PRODUCT
SUPPORT
BULLETIN # 496

SUBJECT: 45-12-0700, 45-12-0710 & 45-12-0999 Gear Case Insulator Boot

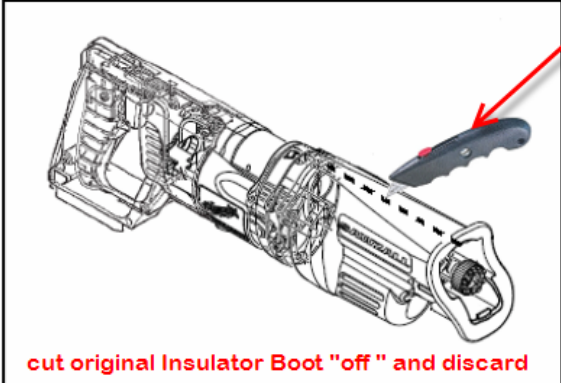
A running change has been made to the 45-12-0700, 45-12-0710 & 45-12-0999 Gear Case Insulator Boot adding material (see illustrations).

We recommend a no-charge replacement of a gear case insulator boot on all Sawzalls (0719-series, 6515-series, 6519-22, 6520-series, 6523-series, 6536-series & 6538-21) received with a damaged boot or upon a customer's request.
